<b>BRIEF DESCRIPTION OF REQUEST</b>
Amend approved Site Plan for Subdivision to develop the approved building pad site into a Starbucks.

**RE: PROJECT - 4201 CENTRAL AVE. NW – ALBUQUERQUE, NM. 87105 (ATRISCO PLAZA SHOPPING CENTER)  
LEGALLY DESCRIBED AS: TRACT A A DIVISION OF LAND OF RANCHO VILLAGE PARTNERS CONT 13.1683 AC  
ADMINISTRATIVE AMENDMENT TO SITE DEVELOPMENT PLAN FOR A STARBUCKS PAD**

#### Transportation Development Comments:

DATE: **16 FEB 2021**  
SCALE: **AS NOTED**  
sheet: **A1.1**  
of: **1**

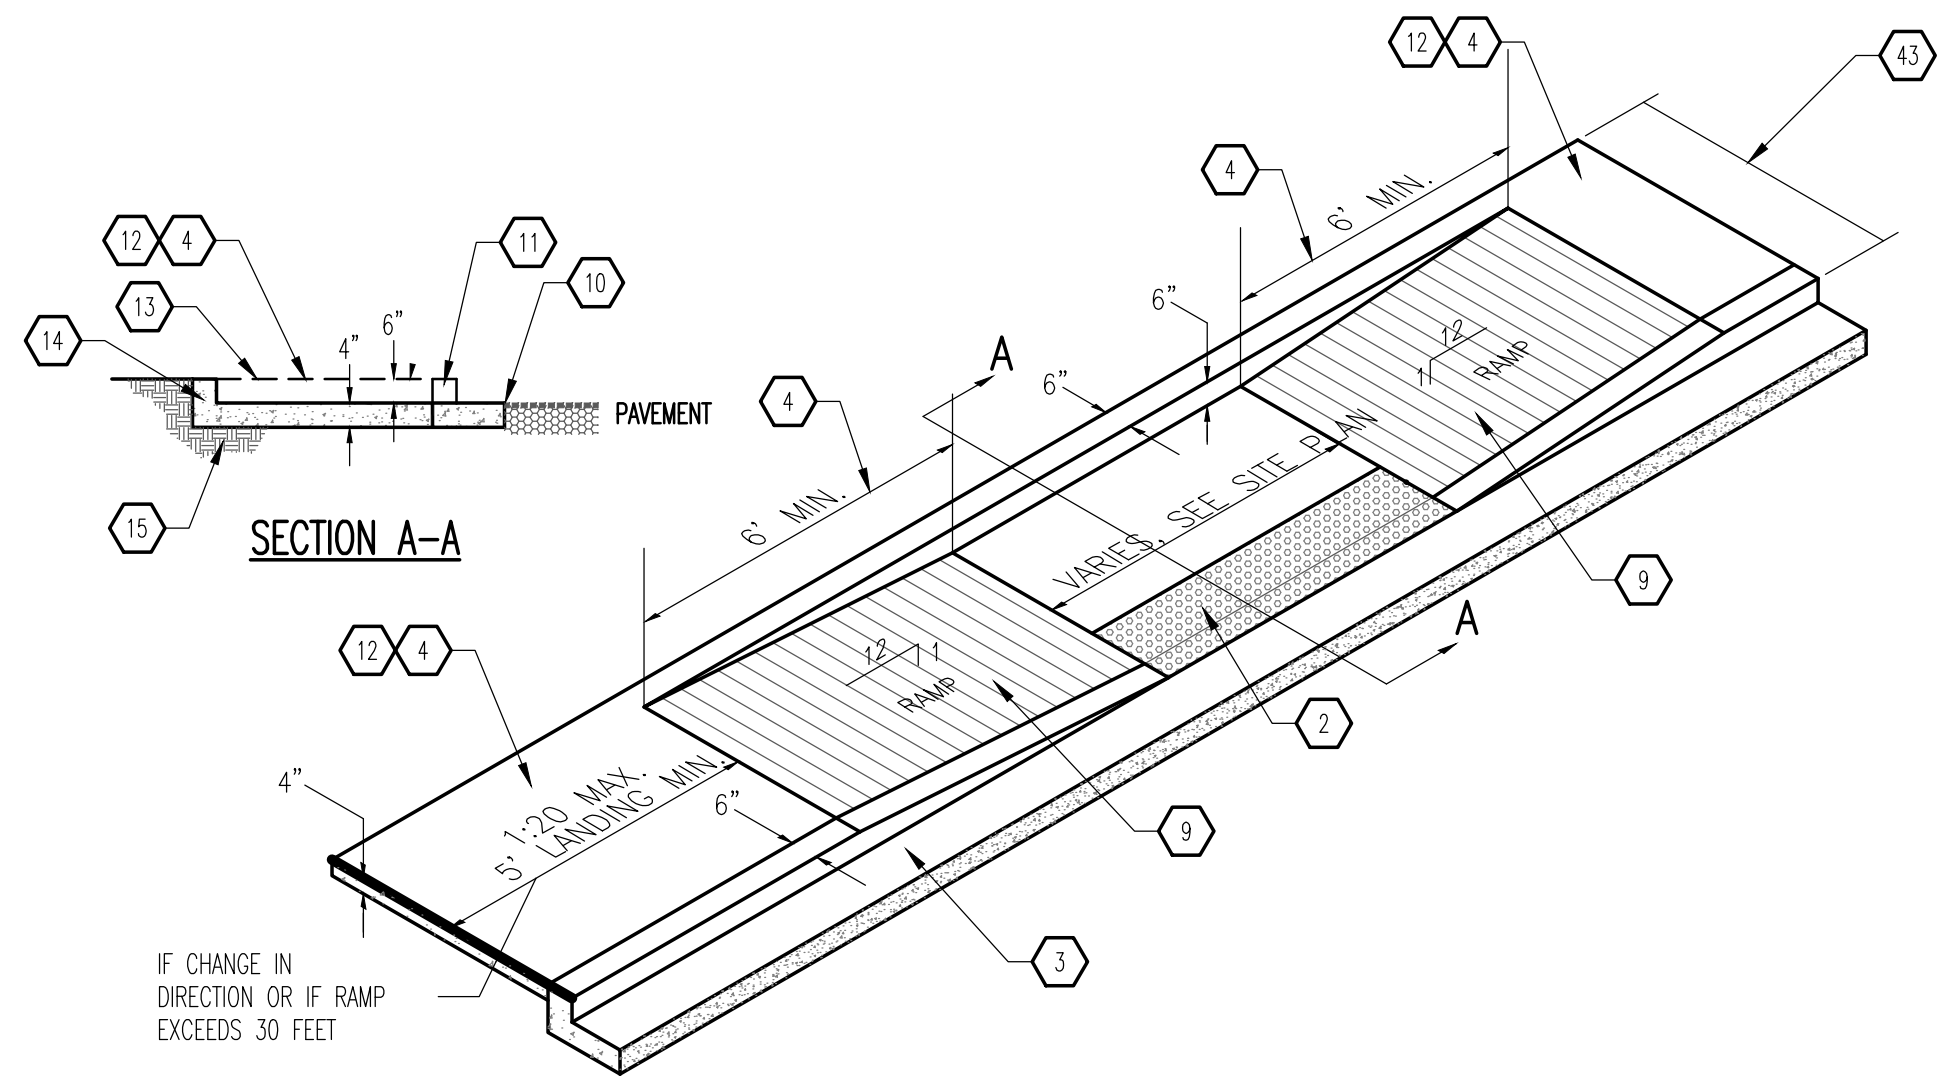
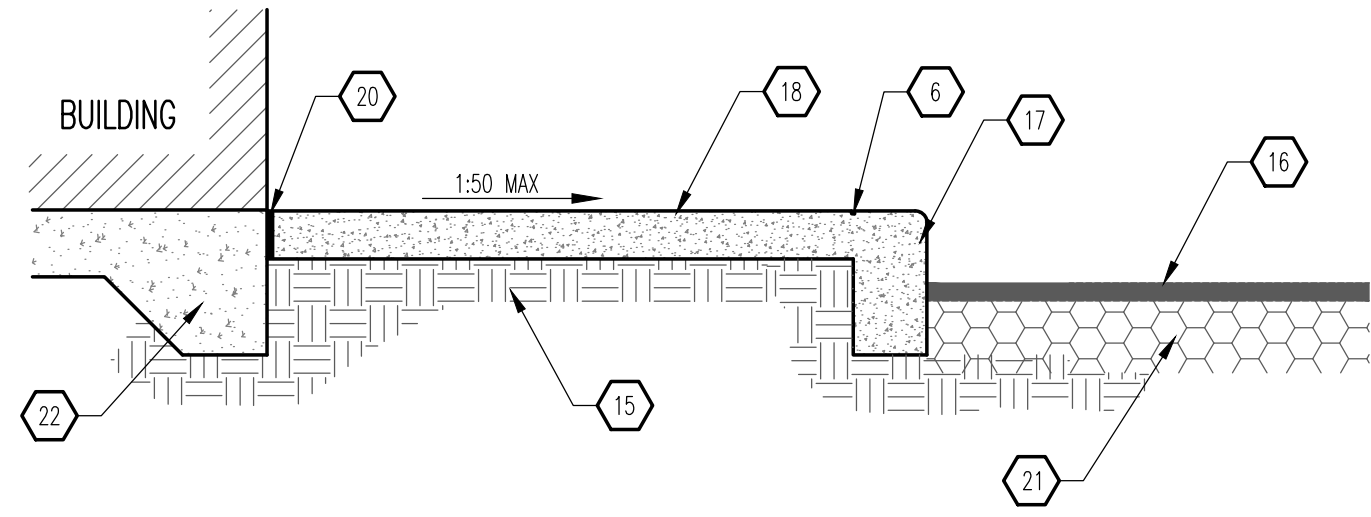
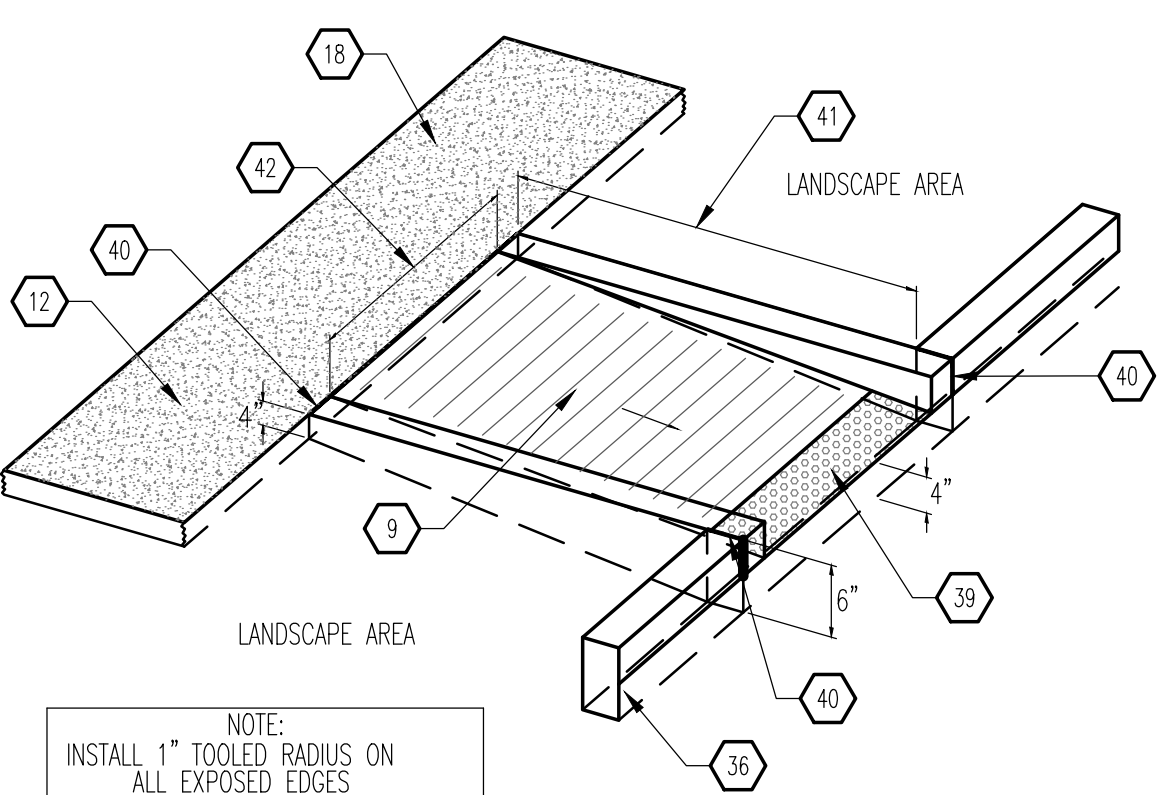
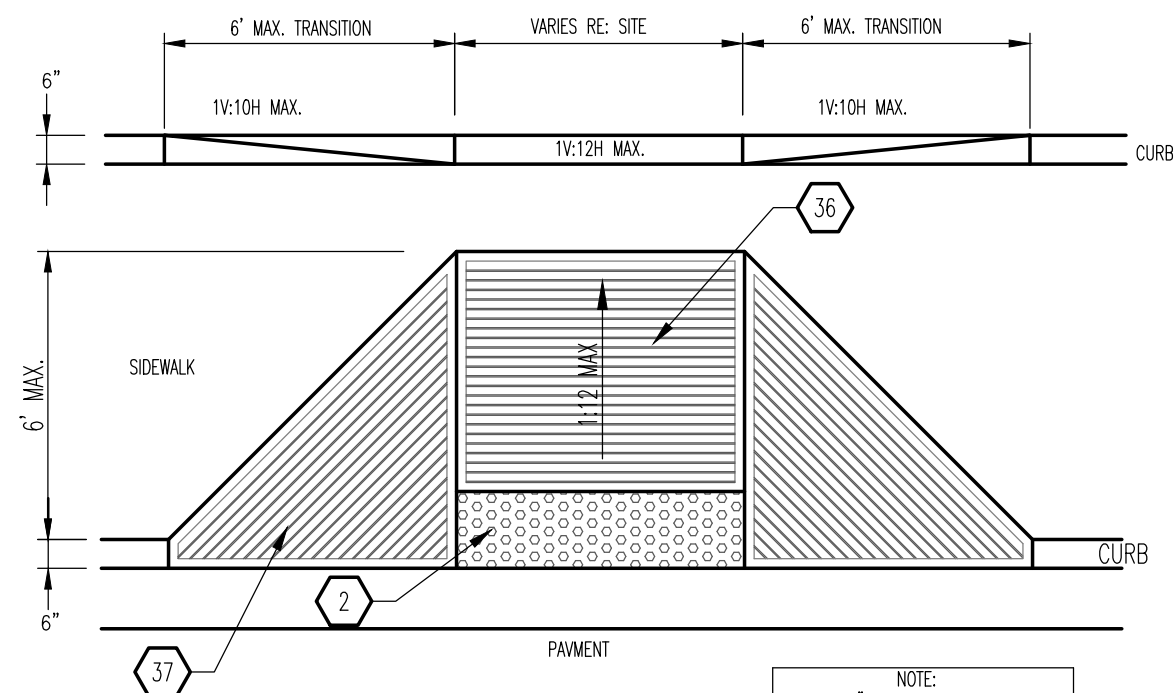
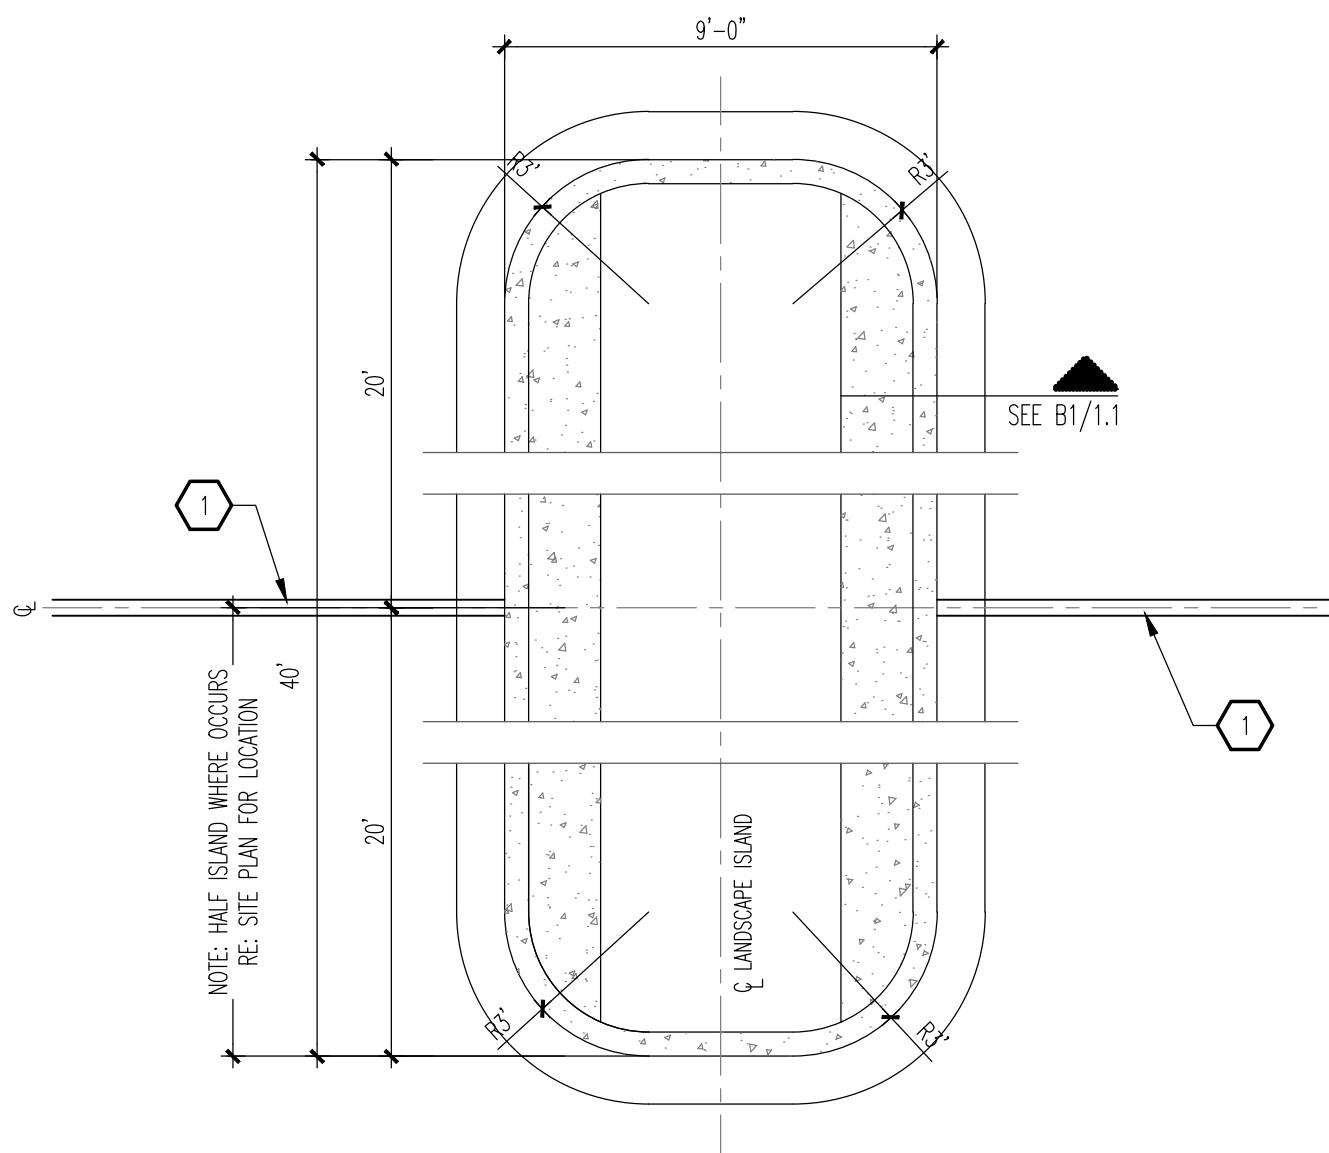
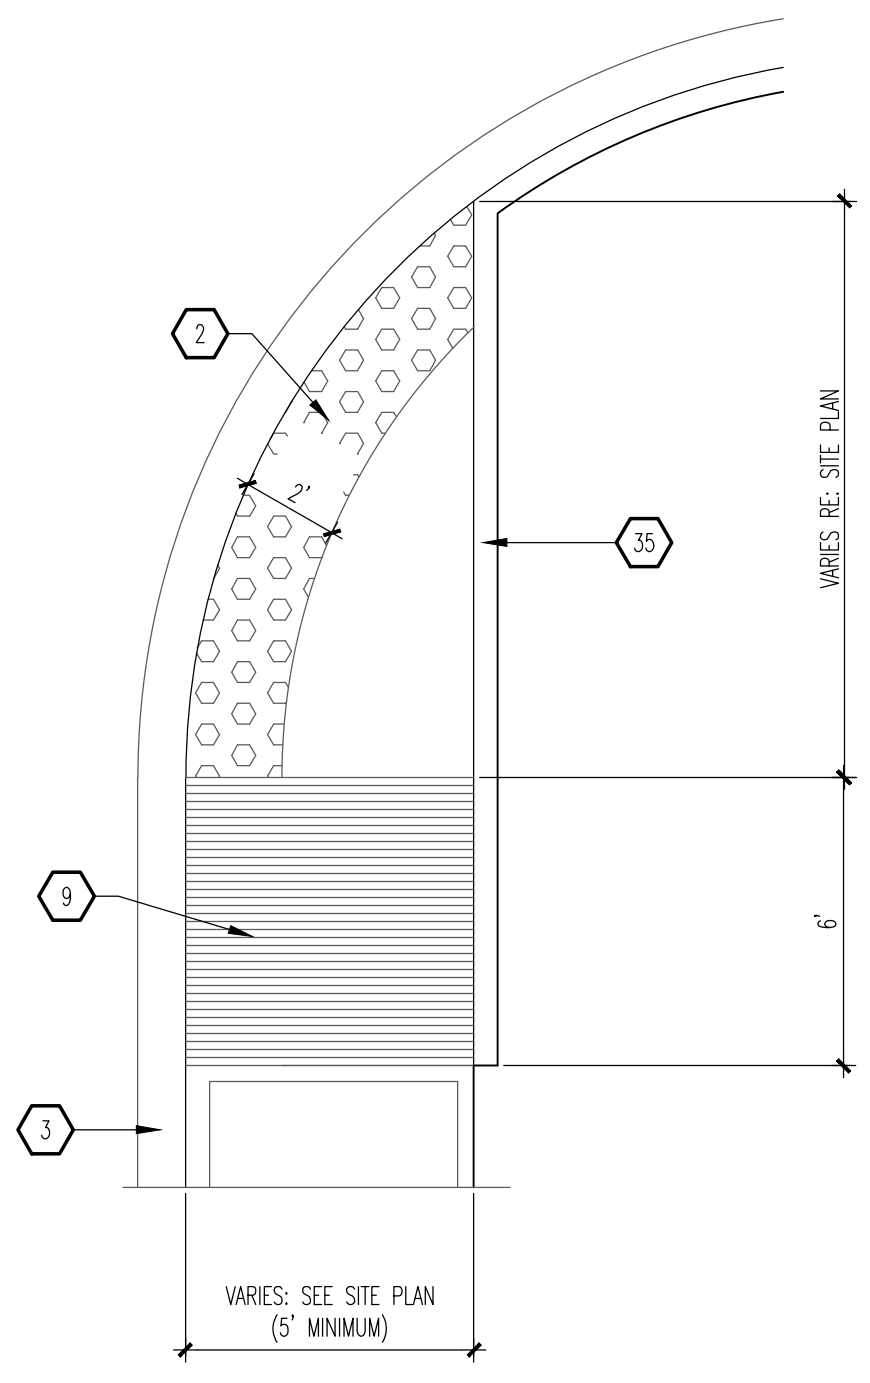
- Show where the motorcycle parking and bike rack are located. **Please see updated site plan on sheet AS102.**
- For all curb ramp details, indicate 6' minimum for length of ramp to ensure it meets maximum slope requirements. **Please see keyed note #41 on sheet A1.1.**

- How much modification will be done to the existing driveway? I just wanted to clarify since the site plan showed less and the details on the details indicated more. Were you just planning to tie into existing? If there are details that are not applicable, you may delete these. (The aerial

shows the truncated domes at this location, and it does not warrant crosswalk striping.) We are to utilize what's existing and tie into it. I've gotten rid on the crosswalk striping on detail C5/A1.1.
